## TECHNICAL SERVICE BULLETIN

### 2020 Explorer/Aviator - Exhaust Rattle Noise

**20-2220**  
29 June 2020

<b>Ford</b> 2020 Explorer
<b>Lincoln</b> 2020 Aviator

Figure 1

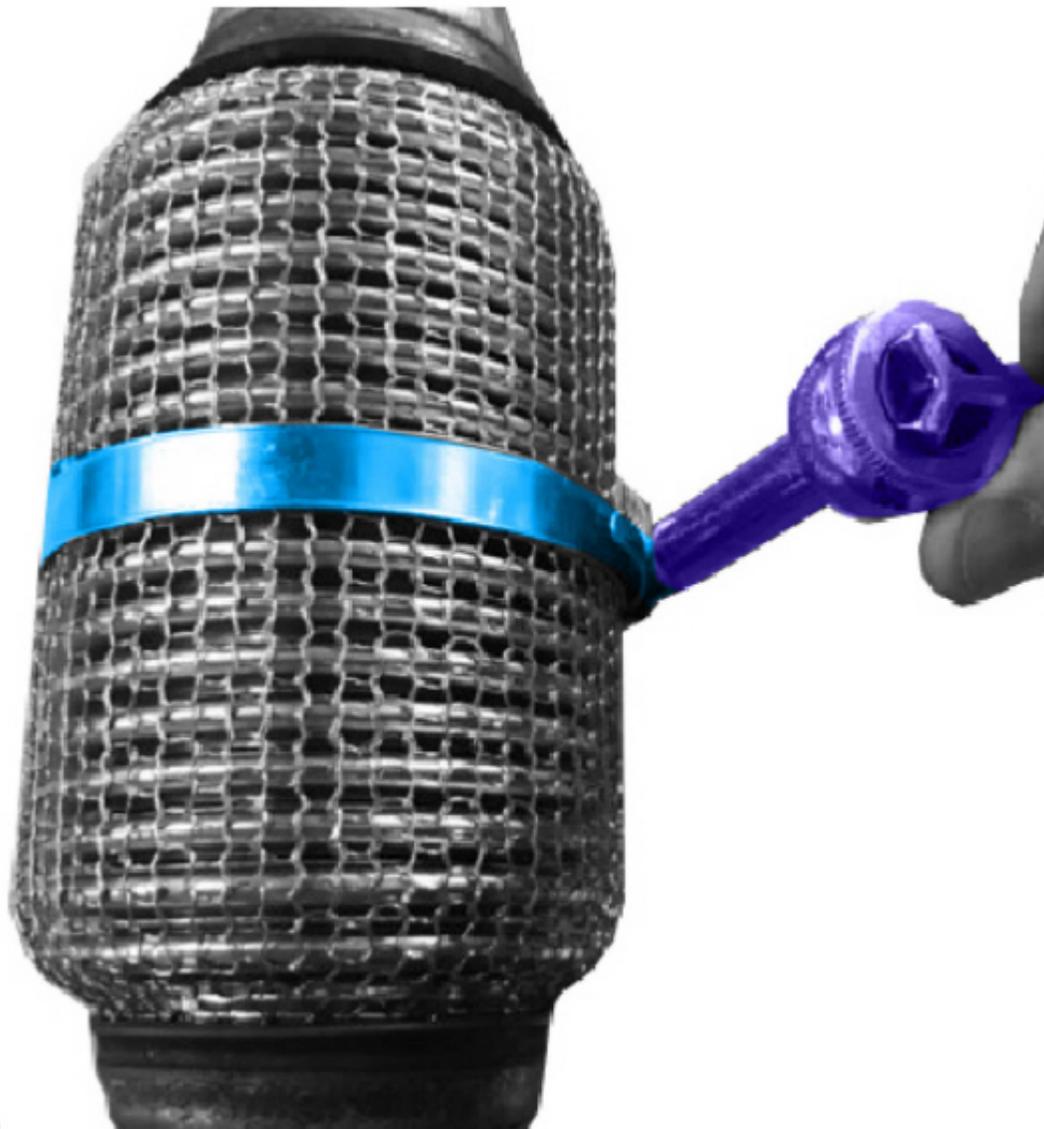
**Issue:** Some 2020 Explorer/Aviator vehicles may exhibit a rattle type noise originating from the exhaust flexible pipe. This may be due to the natural harmonic frequency of the pipe. To correct the condition, follow the Service Procedure to install a worm gear clamp over the exhaust flexible pipe.

1. Open and install the worm gear clamp over the flexible portion of the exhaust flexible pipe. Tighten to 2.7 Nm (24 lb-in) (Figure 1).
